UNITED STATES
NUCLEAR REGULATORY COMMISSION
WASHINGTON, D. C. 20555

APPLICANT: Detroit Edison Company

FACILITY: Fermi 2

SUBJECT: SUMMARY OF MARCH 27, 1981 OL REVIEW MEETING REGARDING REVISED SEISMIC RESPONSE SPECTRA AND REASSESSMENT OF STRUCTURAL AND EQUIPMENT DESIGN MARGIN

Alternative response spectrum plots Fermi-2

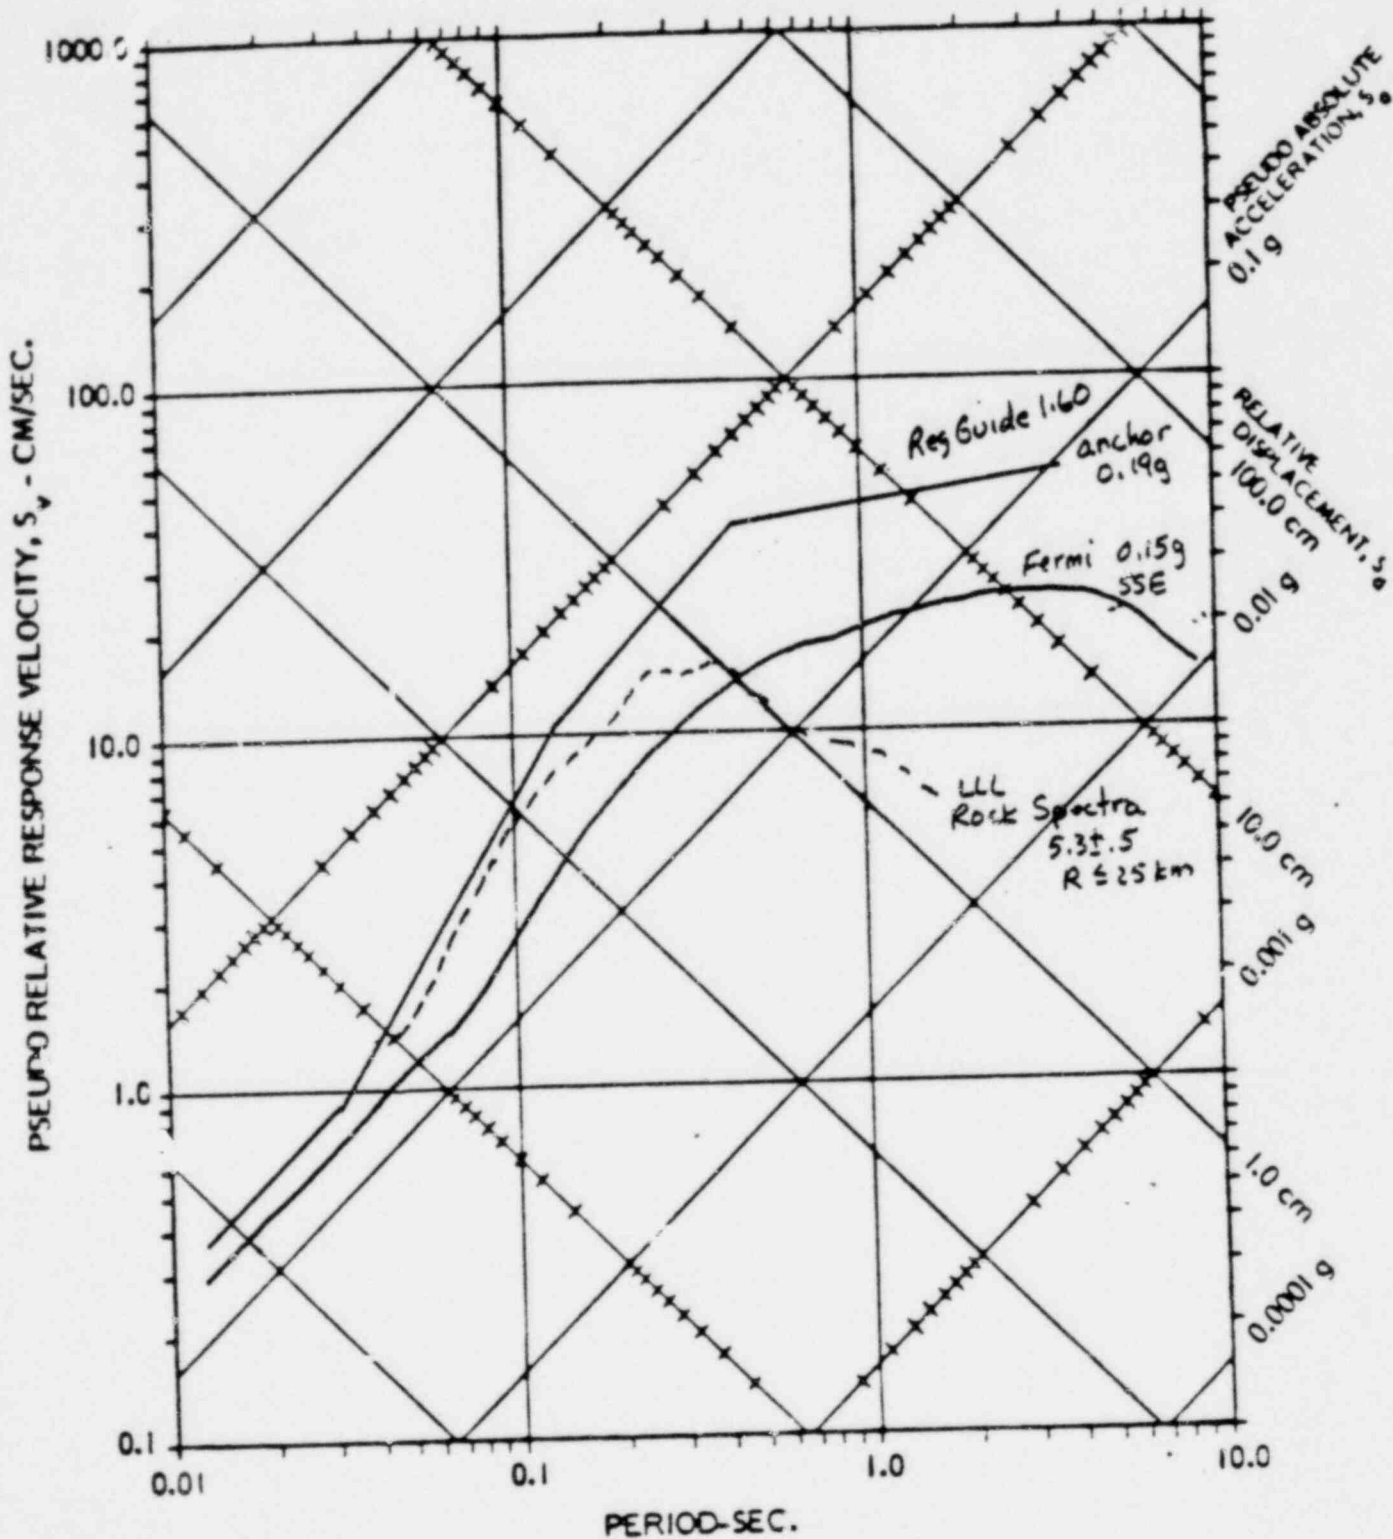
The staff in the Geosciences Branch provided the results of its review of seismic response spectra for Fermi 2. For the construction permit (CP) review, the Seismology Division of the National Ocean Survey (now part of the USGS) assigned a peak acceleration value of 0.15g for the Safe Shutdown Earthquake (SSE). The applicant derived a design spectra by scaling the response spectra from four earthquakes. For the OL review, the NRC staff compared the applicant's spectra with methods currently accepted by the staff. These include Reg. Guide 1.60 and site specific spectra from real time histories. The results are given in Enclosure 2, which shows that the design spectra for Fermi 2 is substantially below currently acceptable spectra. The Safe Shutdown Earthquake (SSE) has not changed for this site from the SSE determined at the CP review stage; however, the characterization of the ground motion produced by the SSE has changed. The staff suggested that the Lawrence Livermore Laboratory rock site specific spectra could be used or an updated site specific spectra could be made. In order to resolve this issue in a timely manner the staff requested documentation of the response spectrum that will be used to define seismic input. As discussed at the meeting the Livermore rock site spectra could also be used as a comparative tool; a spectra which envelopes the Livermore spectra would also be acceptable. Documentation should include a short description of the seismic input response spectrum method chosen and appropriate spectrum plots of the method chosen.

Applicant agreed to performed a reassessment by May 8, 1981. The reassessment will include the selection of a seismic response spectra acceptable to the staff, identification of equipment required for a safe shutdown and assessment of capability for this equipment and associated structures to withstand the Safe Shutdown Earthquake.
